**REQUEST**

Current Zoning: R-3 (single family residential)  
 Proposed Zoning: UR-1(CD) (urban residential, conditional)

The petition proposes the development of 4 vacant parcels in south Charlotte allowing up to 18 single family detached homes, up to 4.97 dwelling units per acre, served by an internal private alley.

**STAFF**  
**RECOMMENDATION**

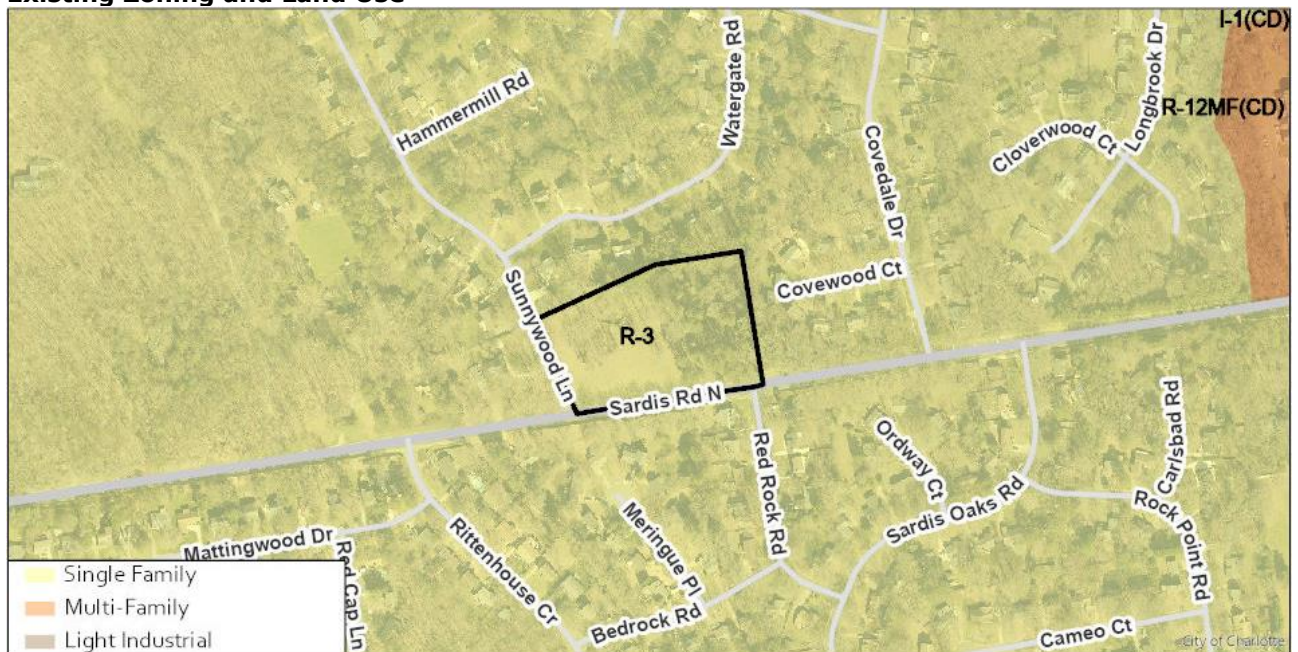
1. Amend the first and second sheets to show and label the setback along Sardis Road North. They should match and commit to the provided setback that is depicted which appears to be roughly 28 feet from the future BOC. **ADDRESSED**
2. Amend the lot dimensions table on sheet 2. Setback should be measured from the future BOC. The setbacks depicted are greater than the minimum 14ft. The table should show 30' from future back of curb for Sunnywood Lane and minimum of 28' from future back of curb along Sardis Road North. **ADDRESSED**
3. Amend the second sentence of note 4a. to say "Along Sardis Road North a building setback with a minimum of 28 feet was measured from the future back of curb will be provided" **ADDRESSED**

6. On sheet 1 amend the label for the building line along Sunnywood Lane to change "existing" to "proposed" **ADDRESSED**
7. Amend the lot dimensions table on sheet 2. Setback should be measured from the future BOC. The setbacks depicted are greater than the minimum 14ft. The table should show 30' from future back of curb for Sunnywood Lane and minimum of 28' from future back of curb along Sardis Road North. **ADDRESSED**

Correct the typographical error in note 3.g changing "re-strip" to "re-stripe" **ADDRESSED**

8. Remove the words "or a tree save area" from note 4.b. because preserved tree save area must have a minimum width of 30 feet. You may add another sentence to say that as generally depicted a tree save area may be provided. **ADDRESSED**
9. ~~Amend the site plan to clarify compliance with Fire Marshal's office comments including the following:~~

- ~~Amend the alley cross-sectional detail to either not show roof overhangs within the 20' zone or if roof overhangs exist that they will be a minimum of 14 feet in height.~~
  - ~~Add a note that pavement, curb and sidewalk will all be an all-weather surface, designed to support a minimum of 80,000 lbs.~~
  - ~~Add a note that no obstructions including lawns will be located within the 20' clear zone.~~
  - ~~Ensure all turn radii shall be 30' inside and 42' outside.~~ All items addressed
-
